OBJECT: DRW 497522 IMPROVEMENT KIT FOR COLD STARTING IN ZIP 50 4-STROKE
Euro 2

PHOTOGRAPH 1
FOTO 1
PHOTO 1

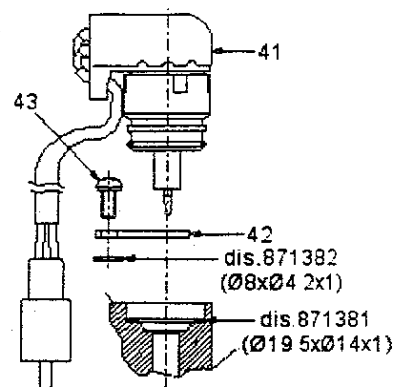
- 9) remove the pipe clamp (drw 709532) fixing the carburettor/filter manifold to the filter housing
- 10) unhook the carburettor/filter manifold from the filter housing
- 11) insert fully to the end the calibrating bushing drw 871174 (photograph 1) in the air inlet hole on the filter housing
- 12) reassemble the carburettor/filter manifold on filter housing and tighten it with the pipe clamp (drw 709532)
